INSPECTION REPORT
Sedimentation Structure
J28-G
Kayenta Mine
Navajo County, Arizona
for
PEABODY COAL COMPANY

Dames & Moore
10139-011-22

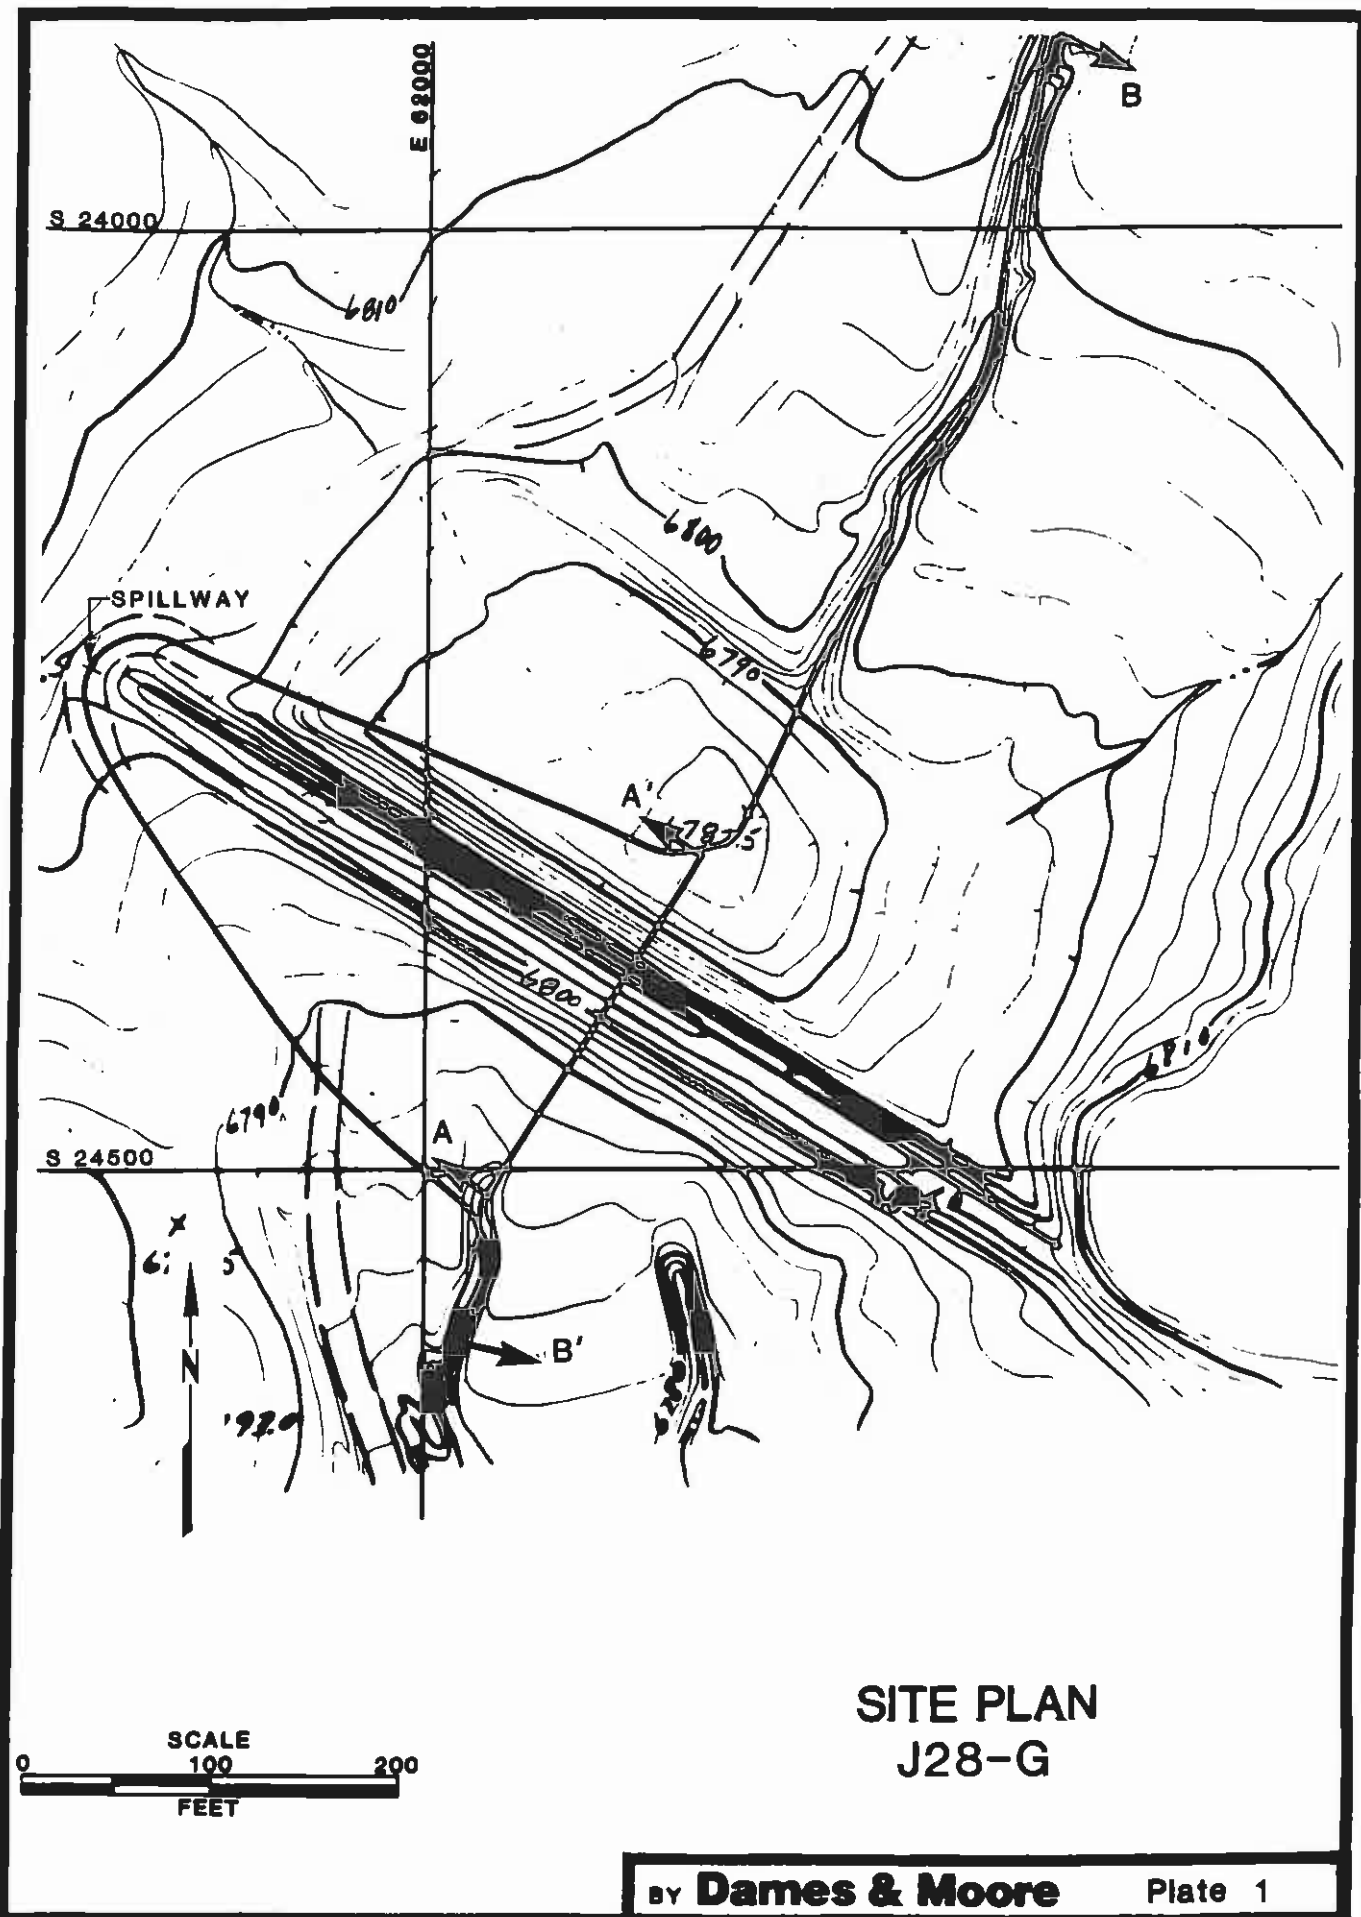
The reduced storage capacity and spillway capacity of Structure J28-G are adequate; however, the spillway and outflow channel do not have adequate erosion protection. Improvements to the trapezoidal outflow channel should be made along the alignment B-B' shown in Plate 1. The channel profile is shown in Plate 4 and the required dimensions are shown in Plate 5. Both the spillway and outflow channel should be protected against erosion using geotextile and gravel as shown in Plate 5.

EXISTING
MAXIMUM CROSS-SECTION
A-A'
J28-G

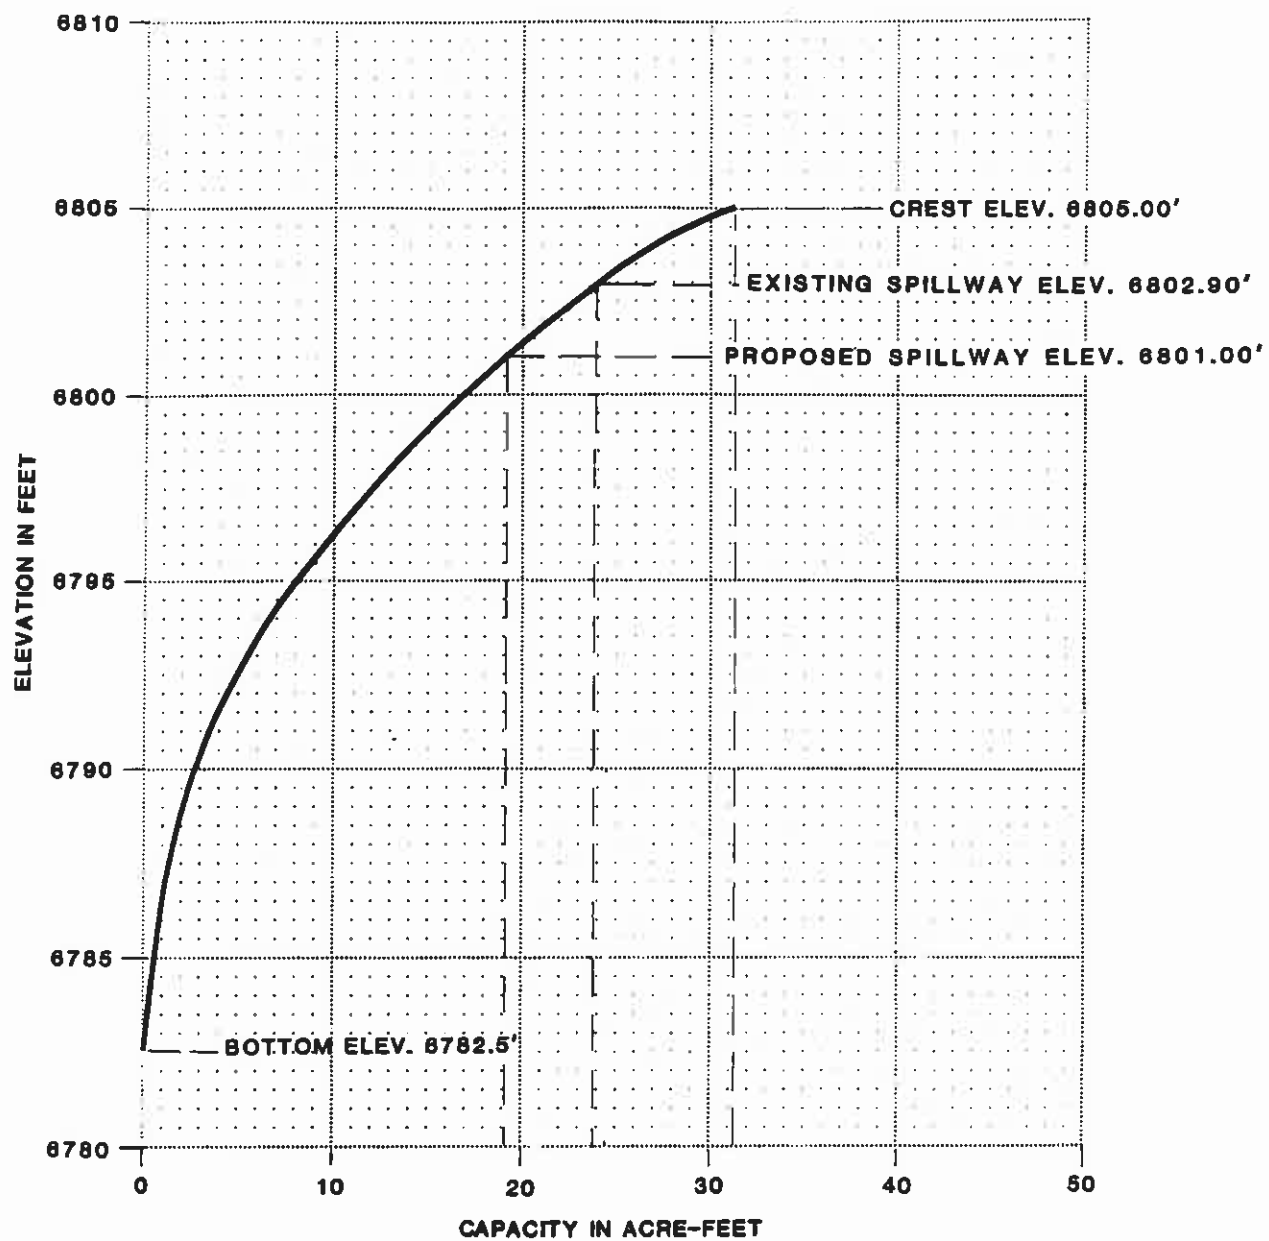
The J28-G embankment is lower in height; however, the downstream slope is steeper than the category standard; therefore, the embankment has factors of safety less than the design minimum.

The downstream slope should be flattened to 2.5 horizontal to 1 vertical to meet stability requirements. The reason for this action is that the present condition may mask evidence of potential future problems.

**VOLUME-ELEVATION
CURVE
J28-G**

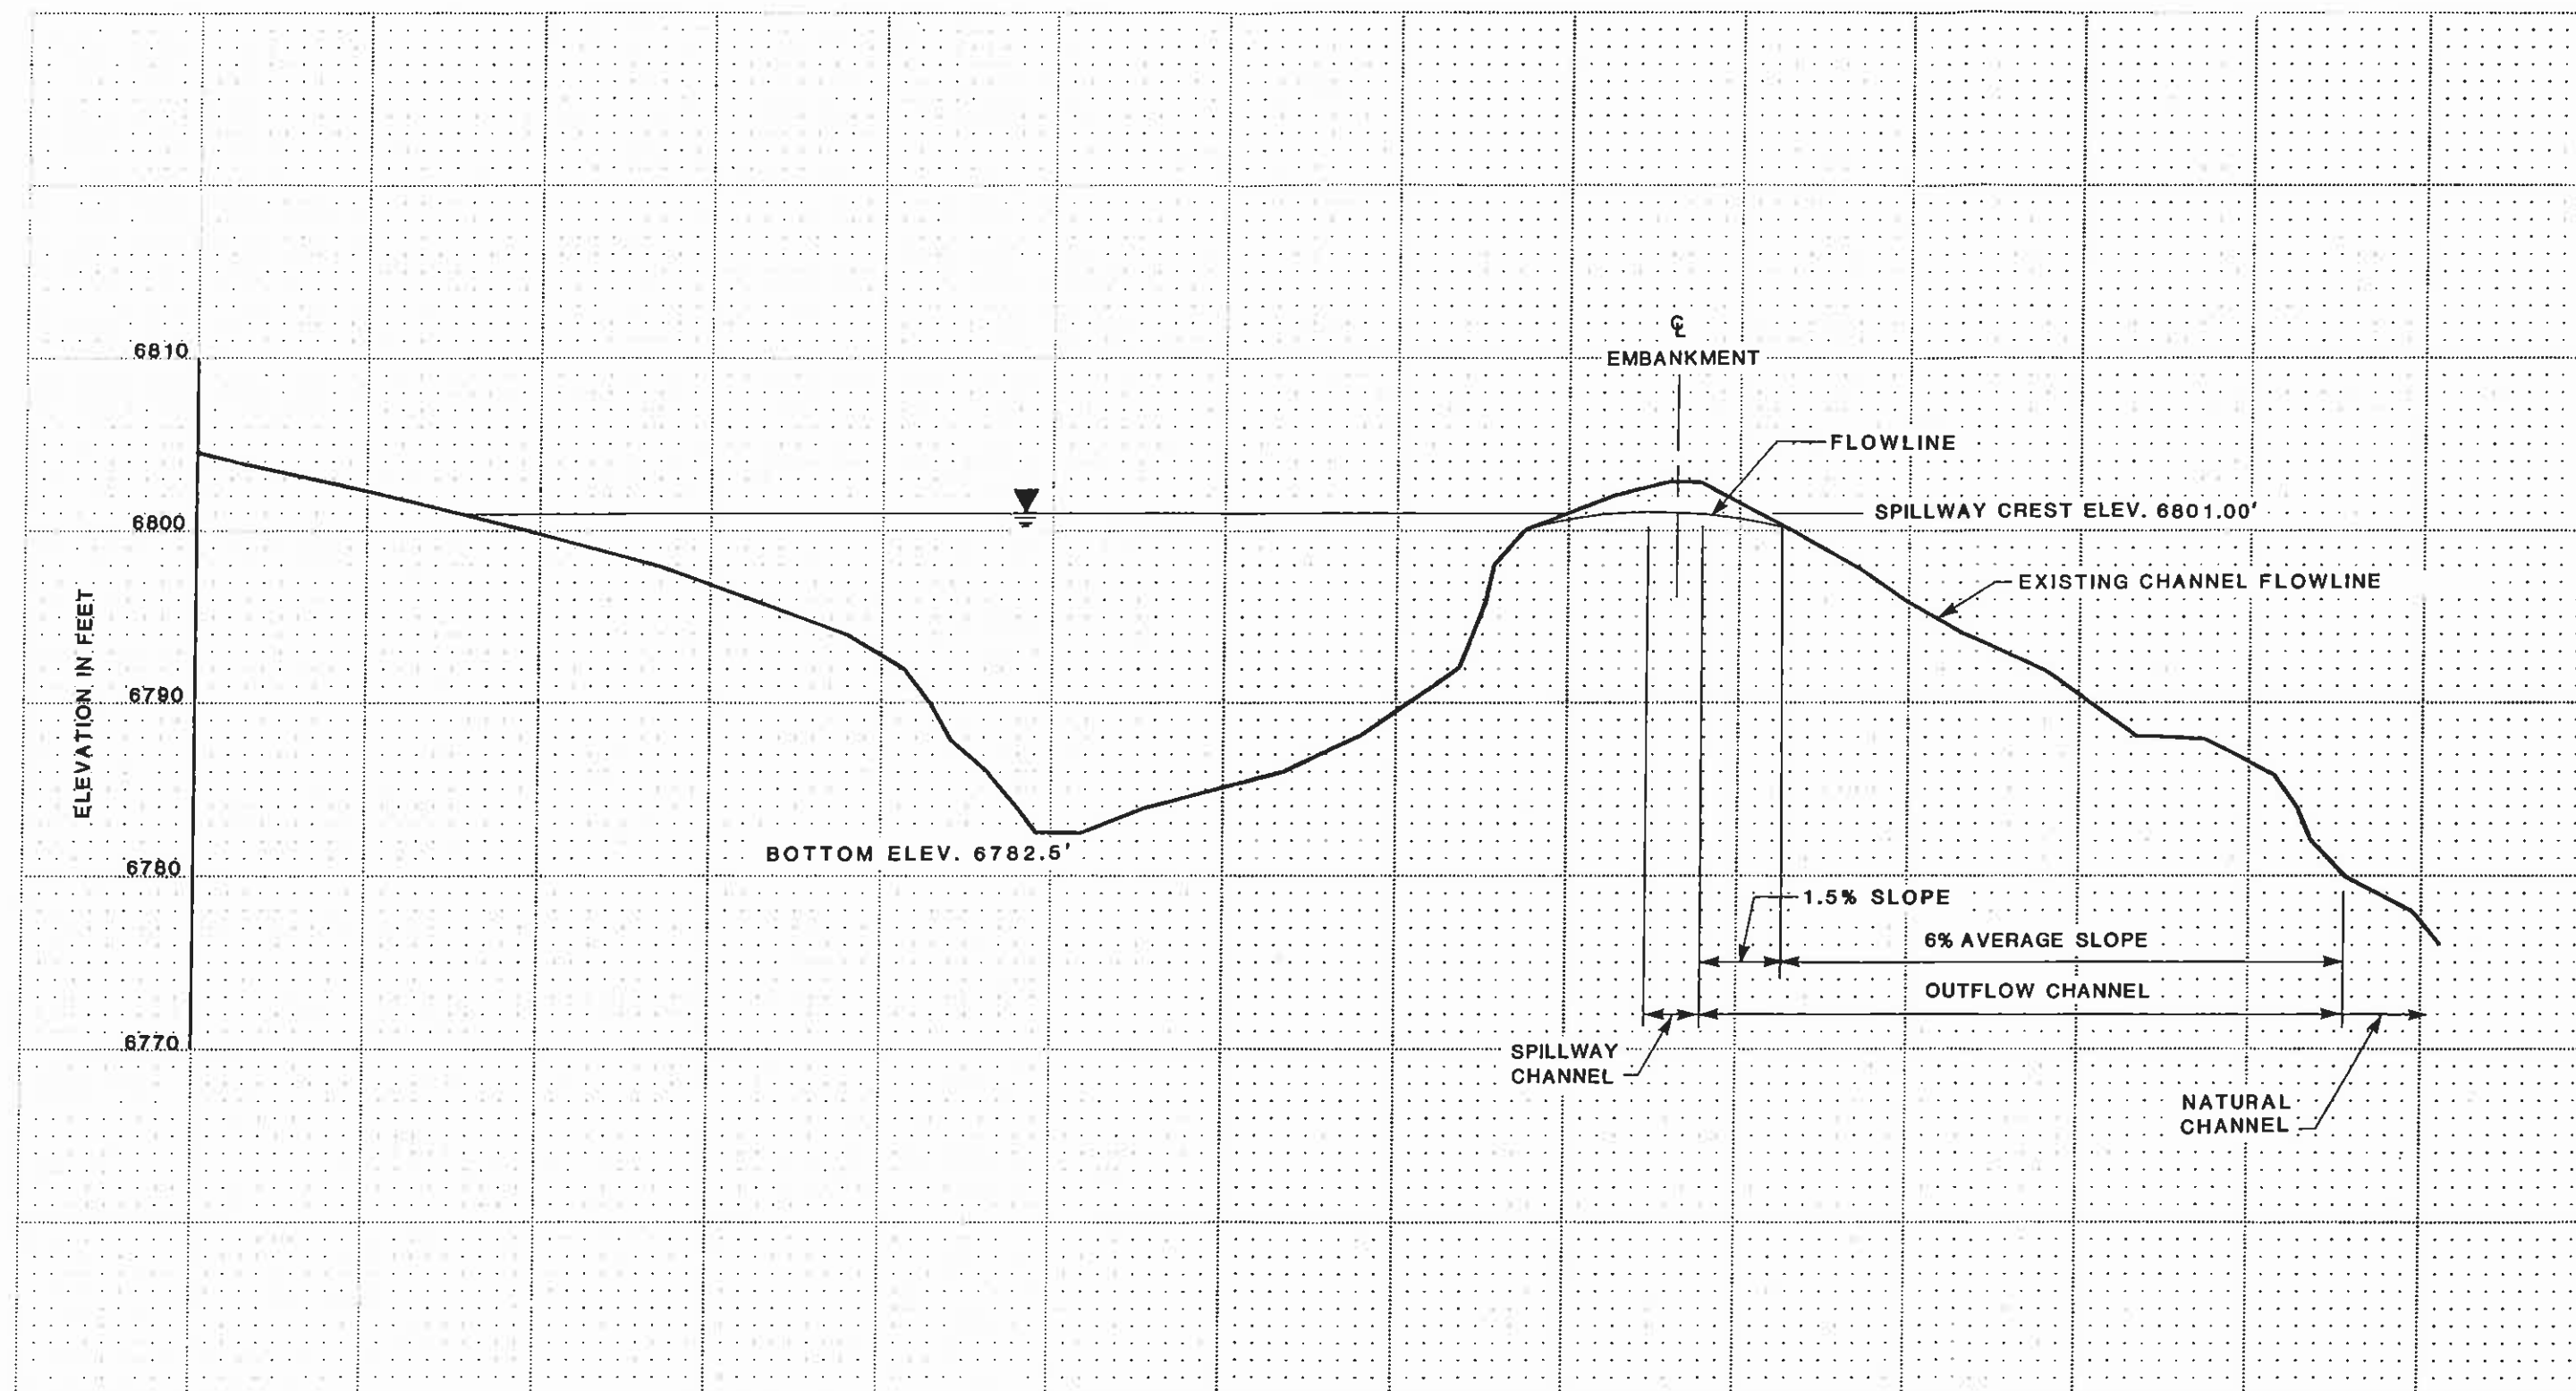
The storage capacity of Structure J28-G exceeds the maximum allowable capacity of 20 acre-feet. The spillway elevation should be reduced to 6801.0 feet, resulting in a storage capacity of 19.22 acre-feet.
